Docket No. 50-213  
B12882

Haddam Neck Plant  
Additional Information Relating to  
Small Break LOCA Analysis Model, NULAP5 (TAC No. 45830)

Response to NRC Questions  
About the  
Oxidation Model in NULAP5

# HADDAM NECK OXIDATION CALCULATION

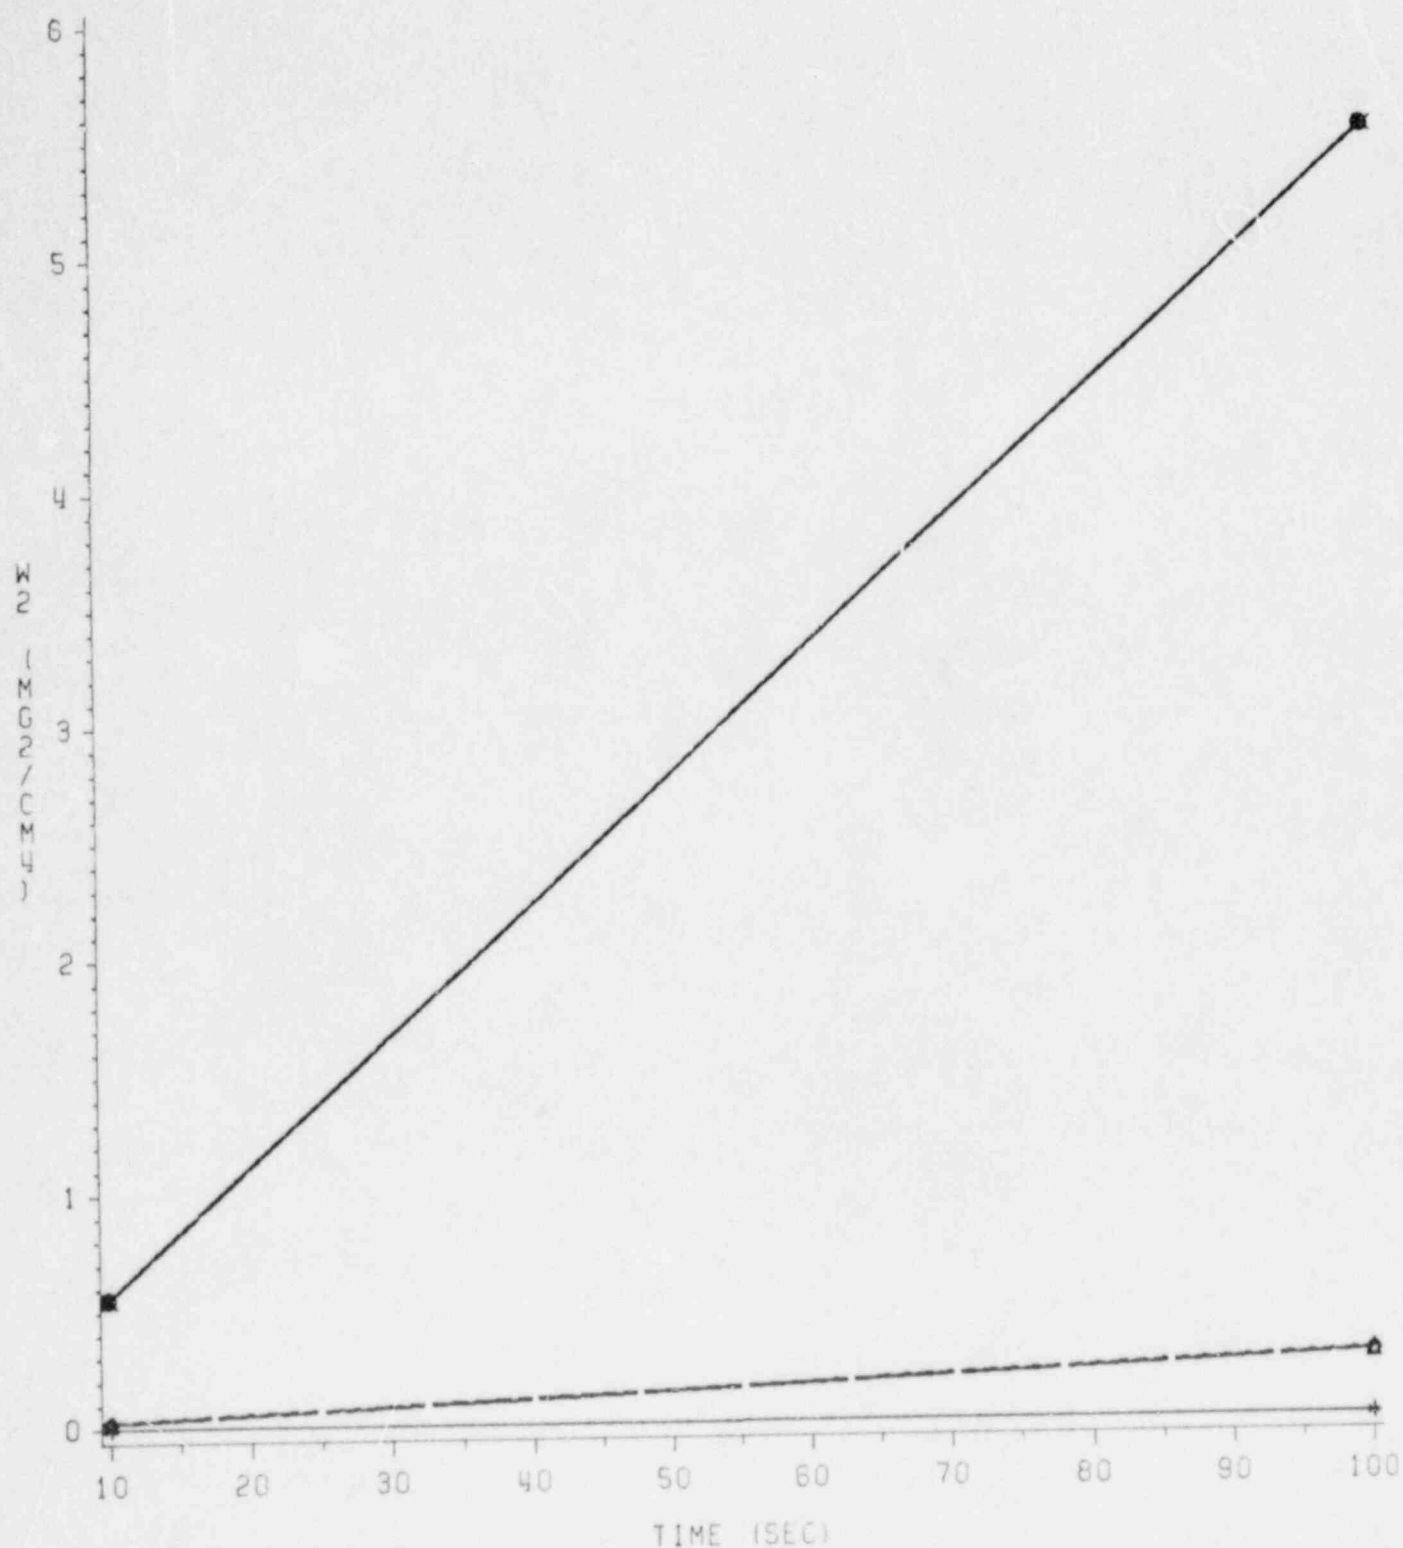
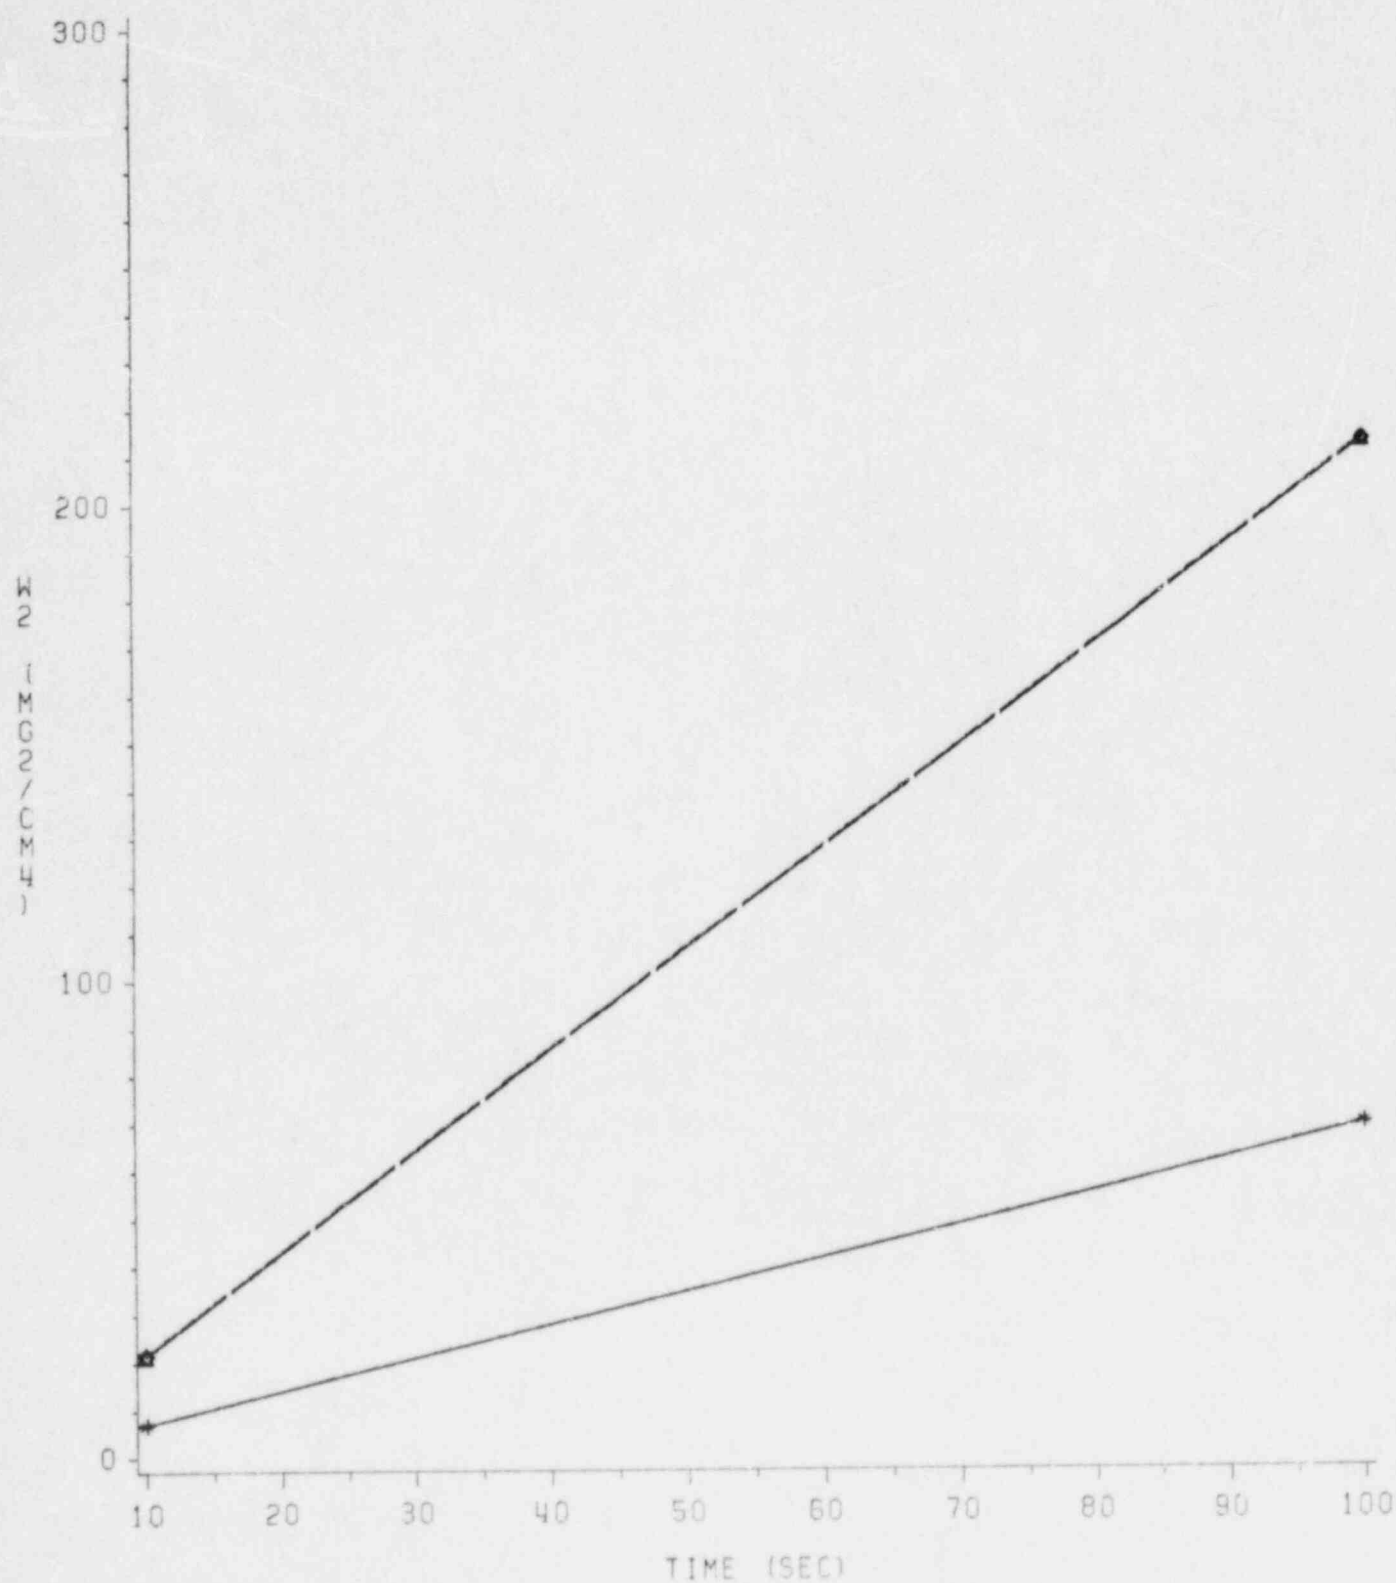
Request: Demonstrate that the oxidation calculation in NULAP5 predicts the appropriate metal-water reaction.

NULAP5 integrates this equation to give a clad thinning and heat calculation as described in previous submittals. The plots that follow show hand calculated values for  $W^2$  and code calculated  $W^2$  at various constant temperatures versus time. Only two points for each temperature are given since at a constant temperature  $W^2$  is linear with time. The lines for the hand calculated plot and the NULAP5 calculated plot overlay each other since, at the same temperature, their values are the same. The plots confirm that the integration of the rate equation is properly implemented.

The temperature at which an appreciable amount of oxidation occurs is in excess of the peak integrated oxidation reported in the submitted topical report. Although the effect of oxidation is insignificant for stainless steel clad fuel during a small break LOCA, the calculation is included in the code. The following plots show that the oxidation calculation is consistent for a range of temperatures and would be consistent and correct for any other temperatures postulated.
